COUNTY OF LOUDOUN
DEPARTMENT OF PLANNING
MEMORANDUM

SUBJECT: September 10, 2009 Planning Commission Worksession
Mount Hope Baptist Church SPEX 2007-0036

SUBJECT: **SPEX-2007-0036 Mt. Hope Baptist Church – 3rd**

SIDE ELEVATION (PHASE 1 & 2)
SCALE: 1/8" = 1'-0"

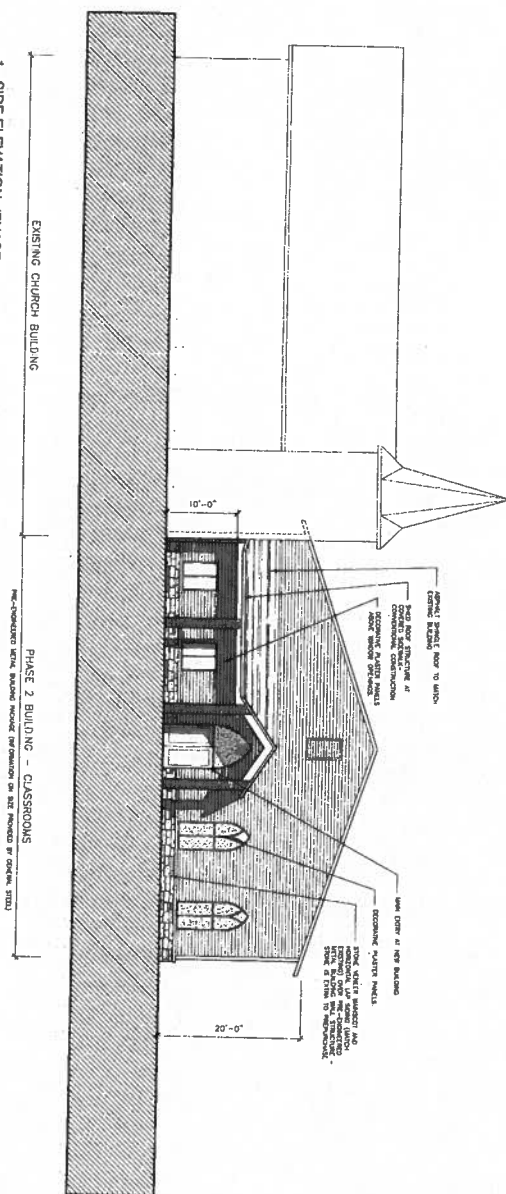
7. **Architectural Elevations.** Review of a special exception application includes giving reasonable consideration to whether the proposed use is compatible with neighboring uses. To facilitate this review, the submission checklist for a special exception application includes submitting elevations for the front, sides, and rear of any proposed structures. In practice, applications have been accepted as complete without elevations. Elevations are often submitted if requested during the referral process, which is the case with this application. The Applicant submitted side elevations for the two buildings that are planned for the first two phases—the buildings to the northwest and southwest of the existing building. Because the Applicant does not anticipate constructing the sanctuary for 15 to 20 years, the Applicant finds it economically unfeasible to hire an architect to prepare the drawings. The SPEX Plat indicates that the sanctuary will be 1½ stories plus the steeple.

Steeple is exempt from the height limitation per Section 1-103.D(2) of the Revised 1993 Zoning Ordinance. The Applicant will be required to comply with the maximum 40-foot building height within the R-1 zoning district.

12. Building Design. To ensure that the proposed buildings, building additions, and enclosed covered walkways are visually unobtrusive from adjacent properties, such buildings, building additions, and enclosed covered walkways shall be consistent with the existing 1899 primary structure in color, materials, design, and architectural features, as shown on the elevations in Exhibit A. For purposes of these conditions, consistent means that the new structures' materials and colors need not exactly match the existing primary structure but shall blend with the existing primary structure and that the design of the new structures shall not copy the existing primary structure but shall reference or repeat some of the architectural features of the existing primary structure (i.e., one or more of the following: window details, siding details, doors, roof color, roof materials, roof pitch and roof form).
